Minutes of Meeting

Working Group C37.012 Application of Capacitive Current Switching for AC HV CB>1000 V

Date: Wednesday April 13th, 2022 (1:30-3:15 PM)

Table 1
Recirculation Comments and Dispositions

Comment ID: 293398 Page 35, Subclause 6.4.2.3, Line 1227

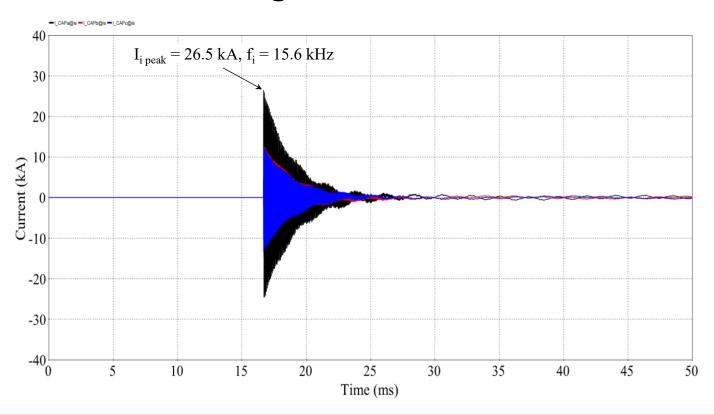
Color graphs are difficult to incorporate into a standard and should only be used when essential. Since there is no legend for the various colors, can they be eliminated?

Remove blue and red colors from Fig. 13 or add legend showing the parameters represented.

Technical	4		508	The definition of "transient overvoltage factor" is difficult to understand and should be improved.	No	The transient overvoltage factor is defined as the ratio of the peak transient voltage appearing during opening between a circuit breaker disconnected terminal and the neutral of the disconnected capacitance to the phase to neutral crest voltage prior to opening.	REJECTED	The proposed change does not add sufficient improvement to the existing definition.
Editorial	3	3	373	According to the IEEE Style manual the defined term should not be in the definition.	No	Delete the introductory words, "Current chopping is" (I think the editors can do this as it does not introduce a change in meaning)	REVISED	Fixed all similar instances in the definitions clause.
Editorial	35	6.4.2.3	1227	Color graphs are difficult to incorporate into a standard and should only be used when essential. Since there is no legend for the various colors, can they be eliminated?	No	Remove blue and red colors from Fig. 13 or add legend showing the parameters represented.	REVISED	Removed blue and red colors from Figure 13.
